CITY OF WEST TORRENS

### COUNCIL ASSESSMENT PANEL

### 8.1 239, 241-243 Richmond Road, RICHMOND

Application No 21028599

PROPRIETOR	OLYMPIC DEVELOPMENTS
PROJECT	PROPOSED WAREHOUSE
	239-241 RICHMOND ROAD
	RICHMOND
DRAWING	ELEVATIONS
DATE	MAR 2022
DRAWN	GP
SCALE	1:200
DWG REF	DA 4A
Rod Roach Architecture	
Tel (08) 8338 5805 E: rr@rodroach.com.au

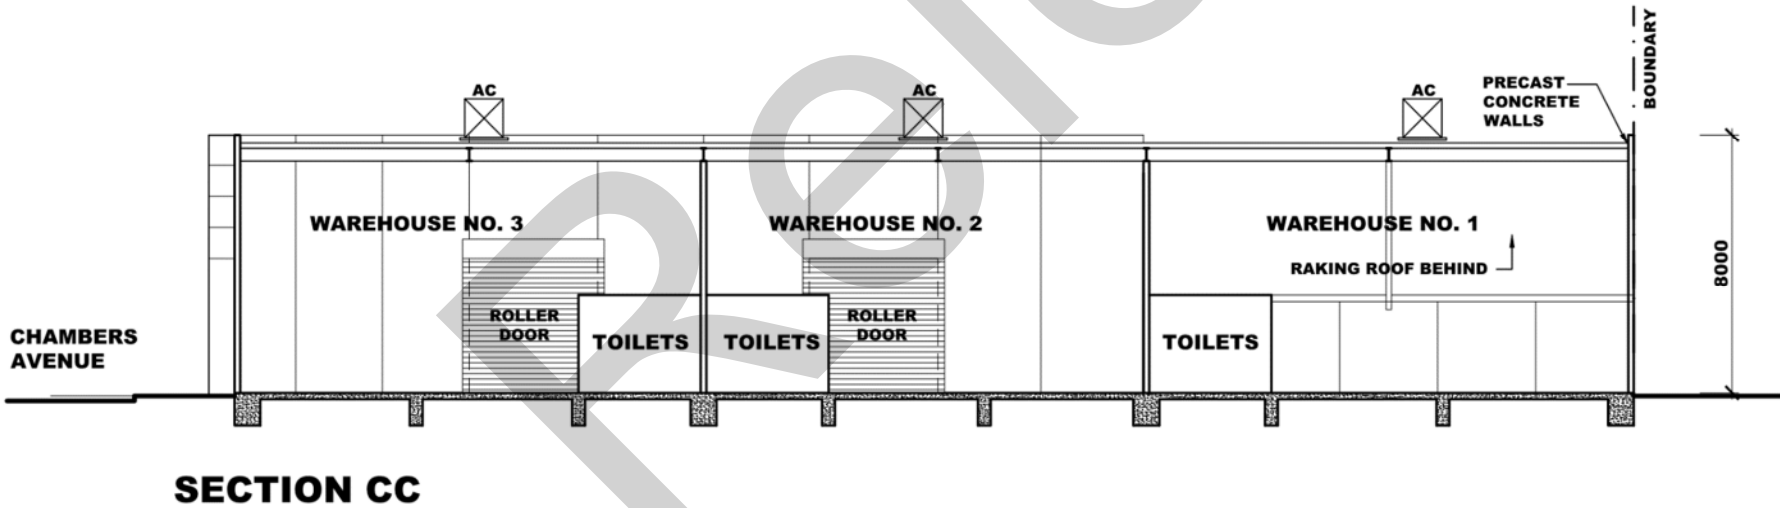
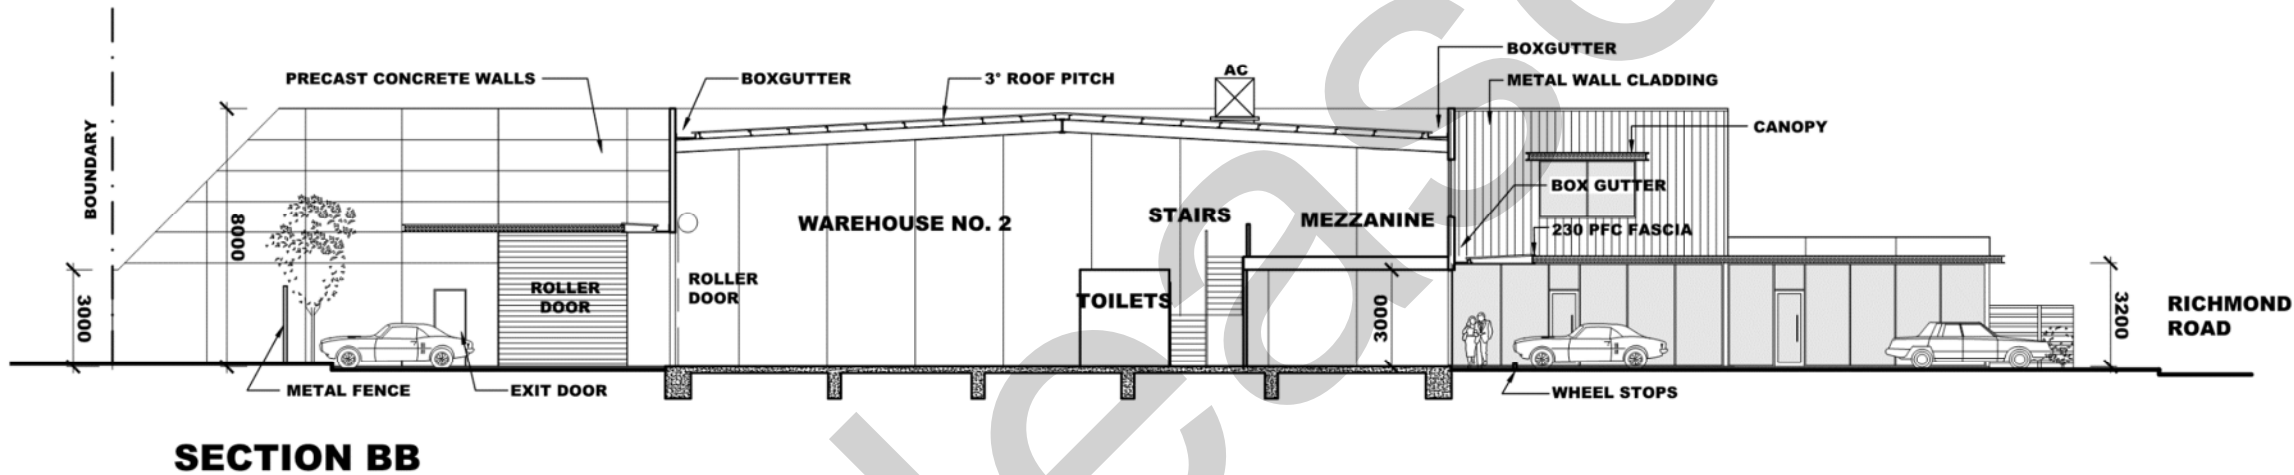
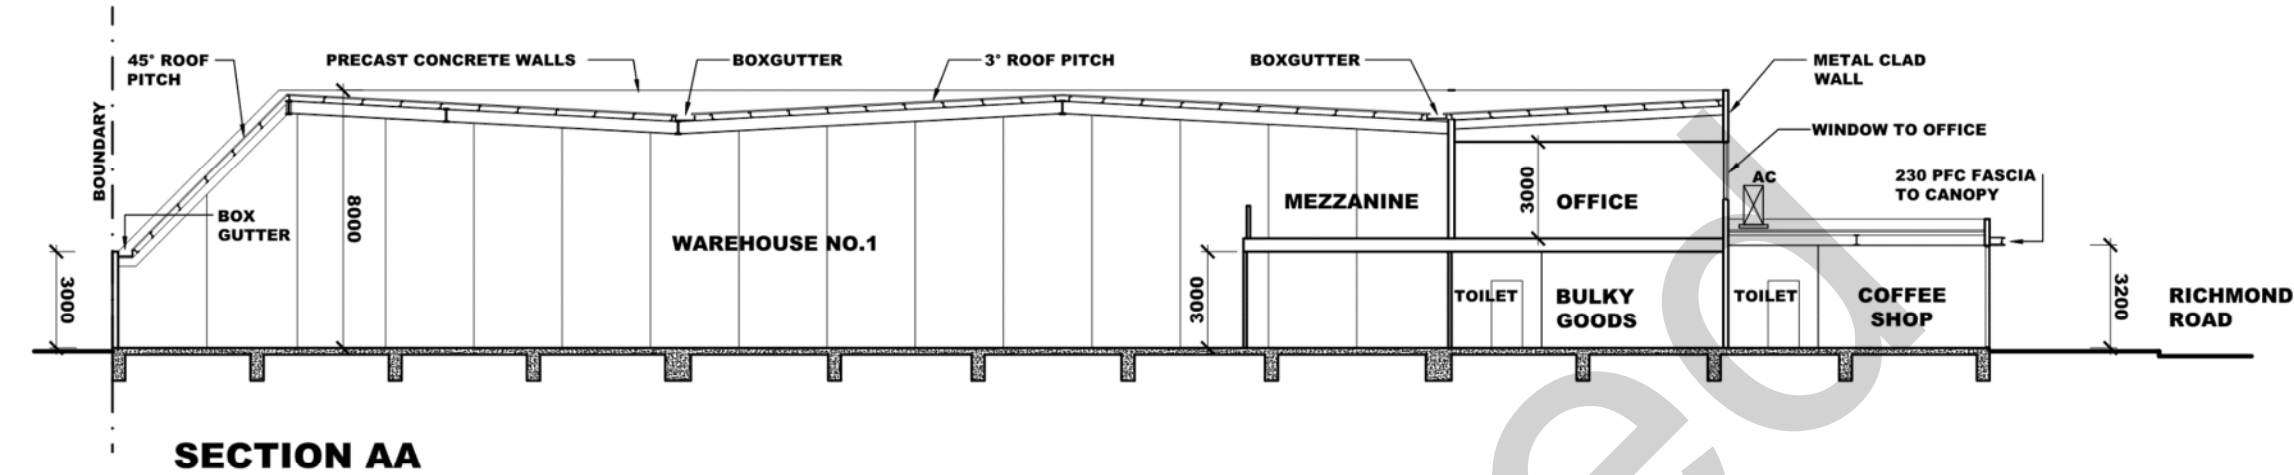
1. The proposal drawings have been amended to provide a minimum setback of 2.0 metres from the closest point to Chambers Avenue. Street alignment. The stepped wall varies from 2.0 metres at the closest point up to 3.0 metres.  
The articulation of the wall in design and materiality has not altered.

Figure 1 Proposed Layout

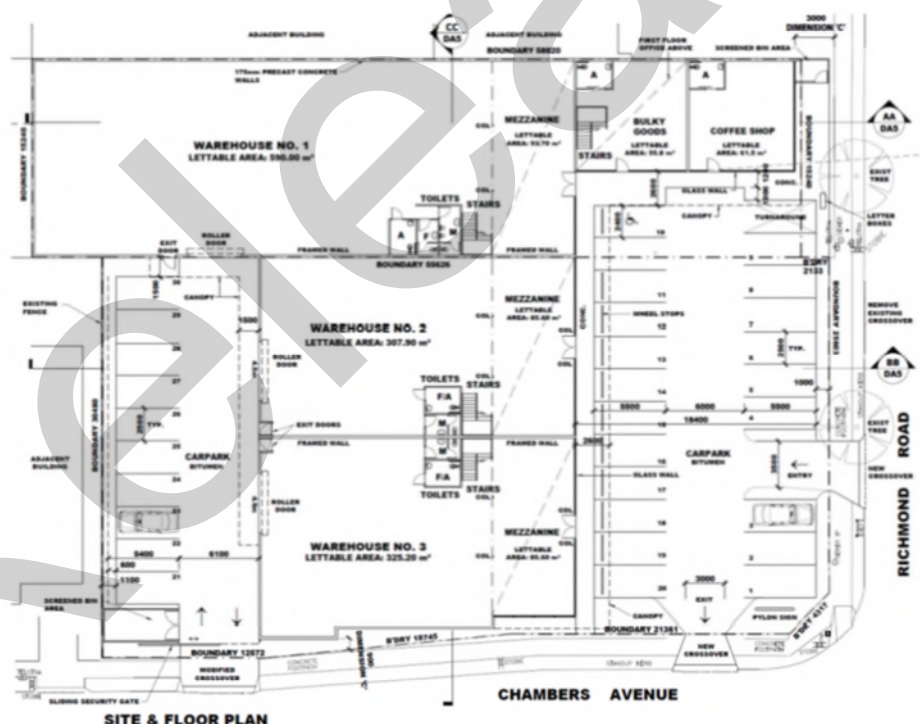
5. *Provide vehicle swept path turn diagrams demonstrating that vehicle movements will be achieved for the largest vehicle expected to access the development and illustrating that two-way passenger car (B99) movements can via the proposed access points occur in accordance with the relevant Australian Standard and in accordance with the Major Urban Transport Routes Overlay.*

6. *A revised site plan demonstrating the above can be achieved.*

A revised site plan has been developed as per the comments in this report.

### 3.1 Parking Layout

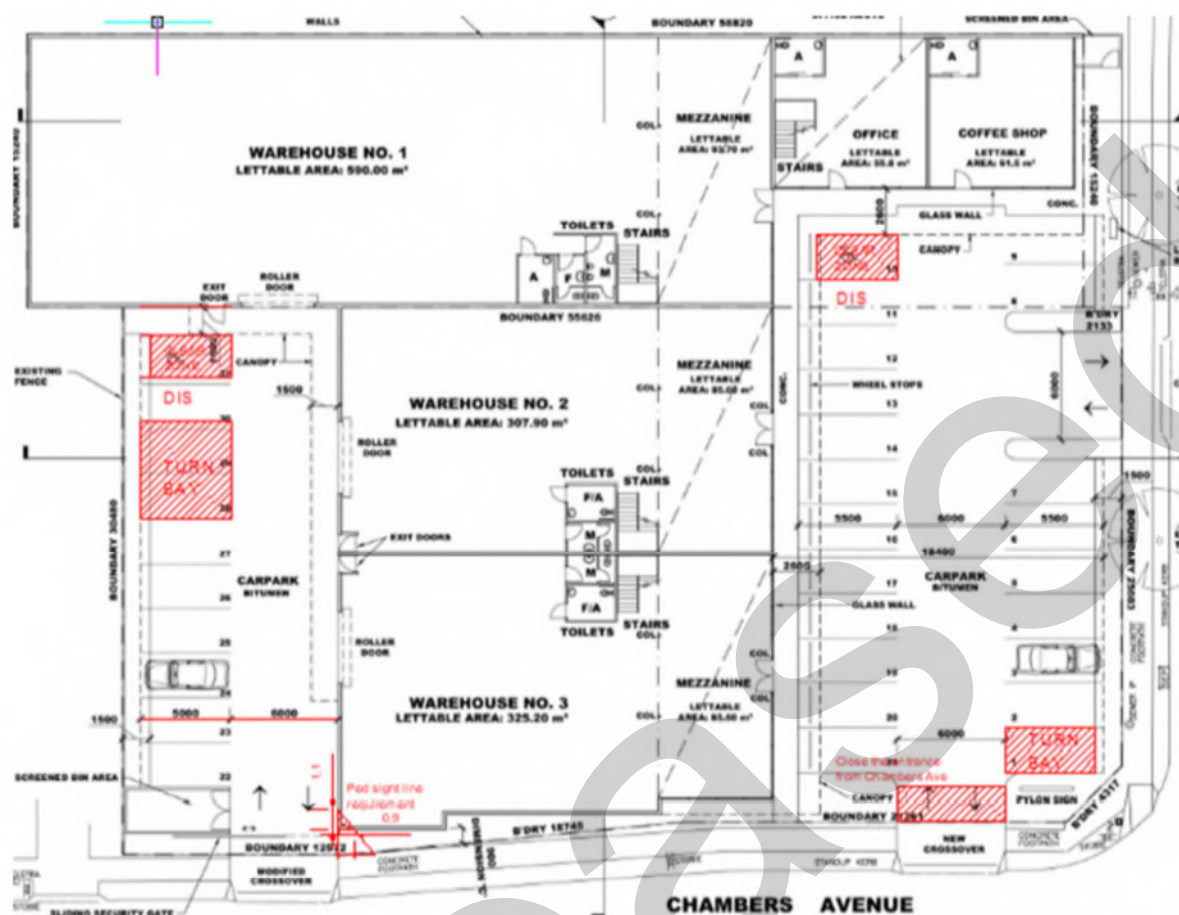
There are a number of amendments required to the parking layout to enable the layout to meet the requirements of the current parking standards and also to deal with the servicing aspects of the proposal.

I note that that there is limited information provided regarding service vehicles that may require access to the warehouses other than the comment that the warehouses would be 'used by occupiers who do not require large vehicle access to the warehouse facilities' (see Rod Roach Architecture Report August 2021 Page 2). Given the constrained nature of the rear car park (Chambers Avenue) where the roller doors of the warehouses are located, my assessment indicates that the 6.4m long SRV truck (as per AS 2890.2-2018) would be able to access the warehouses and rear car parking layout. Vehicles larger than the SRV would not be able to access the roller doors. A condition restricting service vehicles to SRV size for the proposed 3 warehouses would be appropriate.
